REQUEST FOR QUALIFICATIONS

DSP – PLEASANTON ROAD WATER MAIN REPLACEMENT AT HUME ROAD

Solicitation No.: PS-00024-SM

Questions and Answers | February 11, 2016

PLEASANTON ROAD WATER MAIN REPLACEMENT AT HUME ROAD

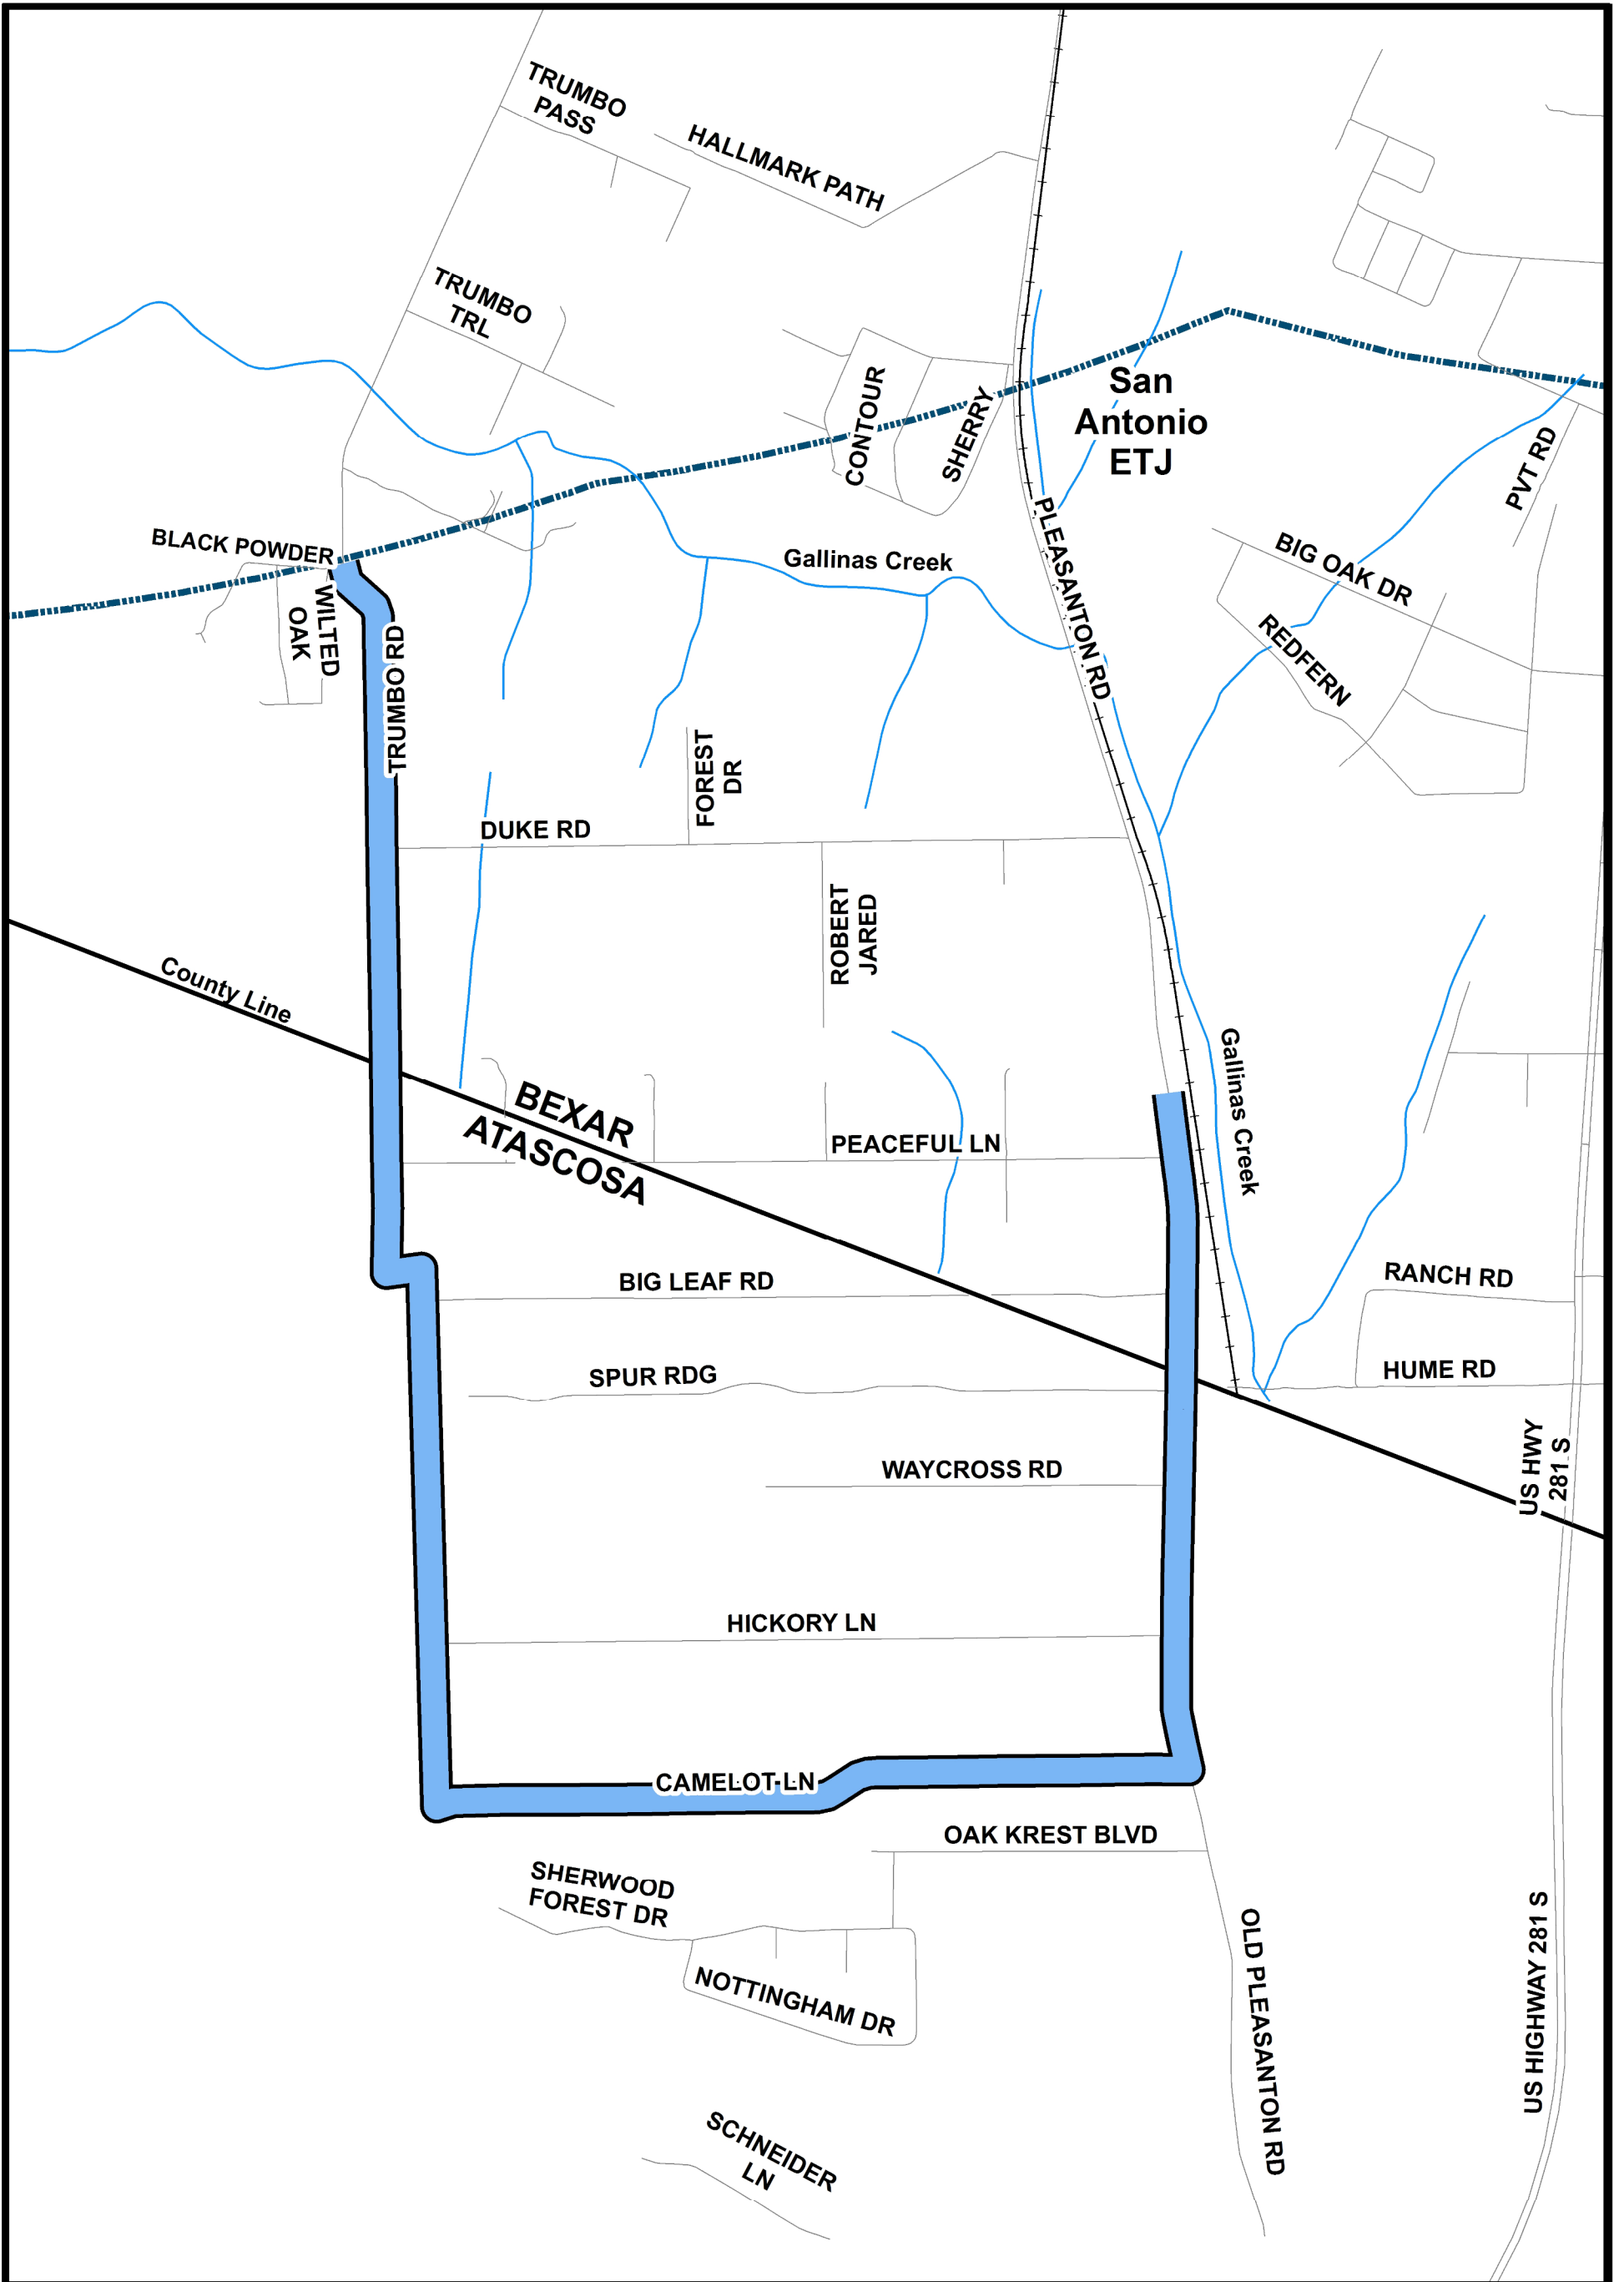
10. Could the project limits please be clarified? Hume Road does not currently cross Pleasanton Road, and Camelot Road is south not north of the location where Hume Road would cross Pleasanton Road (at Spur Ridge).

11. What is the southern limit of the project?

13. What is the northern limit of the project on Pleasanton Road and Trumbo Road?

Please reference Attachment 1 for additional clarification on the project limits.

Please reference Attachment 1 for additional clarification on the project limits.

Please reference Attachment 1 for additional clarification on the project limits.
